Marking Comparison (QSOFP/SSOP)

Migration bottom trace code to top mark

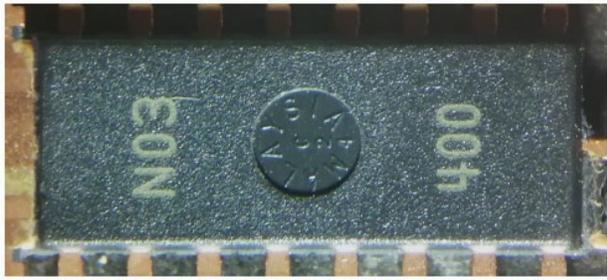
Packages	Current Top	Current Bottom	Proposed trace code to top
SOIC-N 14/16 & GN20/24/28	<p>Original with 2 lines marking</p> 		<p>Bottom trace code migrated to top mark with additional 3rd line</p> 
	<p>Original with 3 lines marking</p> 		<p>Line 2: Combined line 2 with line 3; up to max 16 characters Line 3: To mark N##### trace code</p>
